**HISTORIC ARCHITECTURAL REVIEW BOARD  
CITY OF ALLENTOWN, PENNSYLVANIA  
June 3, 2020**

**FINAL REVIEW**

**Case # HDC-2020-00005** - Proposal to install a stained glass window

<b>Property Location:</b>	731 W Turner Street	<b>Property Owner:</b>	E. Keller & Marguerite Kline
<b>Historic District:</b>	Old Allentown	<b>Owner Address:</b>	731 W Turner St, Allentown, PA 18102
<b>Case #</b>	HDC-2020-00005	<b>Applicant:</b>	(Same as Owner)
<b>HARB Meeting date:</b>	May 4, 2020 (Agenda Item #3)	<b>Applicant's Address:</b>	(Same as Owner)

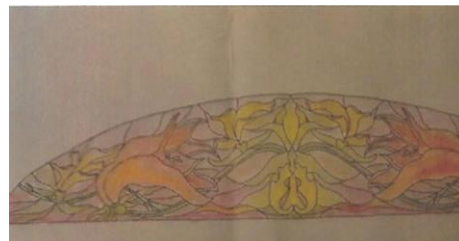
Evaluation, effect on historic district, recommendations: The effort to recreate the stained glass window lost in a car bomb explosion in 2018 is to be praised. The proposed new window is historically appropriate and similar to, but differentiated from, the design and appearance of the original. The stained glass should be installed in a wood sash as seen in the Google Street view photo.

**HARB Discussion:** The HARB was happy to see a new stained glass transom sash being installed. The applicant explained that the sash was lost in the bomb explosion last year. The HARB had little discussion, but Ms. Jackson asked if the design was appropriate since it did not match the historic stained glass design. The applicant said it was no longer possible to get some of the stain glass colors anymore, he thought an interpretation of the design would be OK. The Historic Consultant said it was historically appropriate to differentiate the new window from the old as defined in the Secretary of the Interior Standards. It was clarified that the new stained glass panel would be installed in a wood sash.

1. The proposal to install a stained glass window at 731 W Turner Street was represented by Keller Kline.
2. The stained glass window presented at the meeting will be installed in a wood sash matching the arched shape of the historic opening.
